Access Compliance Report Public Rights-of-Way (Curb Ramps)

Main Street: YARDLEY_ST Cross Street: BALL_RD Location: SE

ADA ID: RPRK210927150129 Ramp Type: Type 7 - Directional 2 Initial Pass/Fail: Pass Overall Compliance: No Severity Score: 6

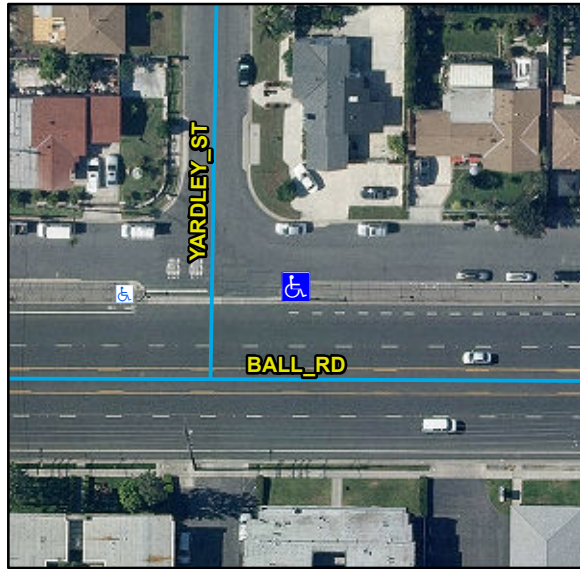
Compliance	Description	Data	Compliance	Description	Data
N/A	Ramp Length (in)	102	N/A	Flare Type LT	
Yes	Ramp Width (in)	54			None
Yes	Ramp Run Slope (%)	3.7	N/A	Flare Slope LT (%)	N/A
Yes	Ramp Cross Slope (%)	0.1	N/A	Flare Traversable LT	N/A
No	Grade Break	No	No	Flare Type RT	
N/A	Grade Break Slope (%)	N/A			Curbed1
N/A	Grade Break Cross Slope (%)	N/A	N/A	Flare Slope RT (%)	N/A
	Addl Para Ramp Left?	No	N/A	Flare Traversable RT	N/A
	Addl Para Ramp Right?	No	Yes	DWS Provided	Yes
N/A	Landing Present	Yes	Yes	DWS Contrast	Yes
Yes	Landing Length (in)	60	Yes	DWS Length (in)	54
Yes	Landing Width (in)	54	No	DWS Full Width	No
Yes	Landing Run Slope (%)	2		DWS Offset Type	Single
No	Landing Cross Slope (%)	4.1	Yes	DWS Left Offset (in)	0
N/A	Landing Movement Obstructed?	No	N/A	DWS Right Offset (in)	0
	Landing Movement Type	N/A			
N/A	Landing Shared	No			
N/A	Marked Crosswalk 1	No	N/A	Clear Space	N/A
	Crossing 1 Direction	W	N/A	Clear Space To Crosswalk (in)	N/A

N/A	Marked Crosswalk 1 Width (in)	N/A			
N/A	Ramp Inside Crosswalk 1	N/A			
	Crossing 1 Slope (%)	3.4			
	Crossing 1 Cross Slope (%)	2.2			
Yes	Gutter Ponding	No	Yes	Curb Slope	7.5
Yes	Gutter Lip Height (in)	0		Road Run Slope (%)	N/A
Yes	Gutter Run Slope (%)	3.4		Road Cross Slope (%)	N/A
No	Gutter Cross Slope (%)	7.8		Parallel Ramp Side	Right
Yes	Overall Surface Condition	Acceptable	No	Perp Joint Present	No
	Cross Gutter Present?	No		Spandrel Present?	No
	Replace Cross Gutter?	N/A		Replace Spandrel?	N/A

Remove & Replace Entire Ramp. Remove & Replace Gutter.

R204.3, R304.5.3, R304.5.2, R304.2.3, R305.1.4, STD 1115
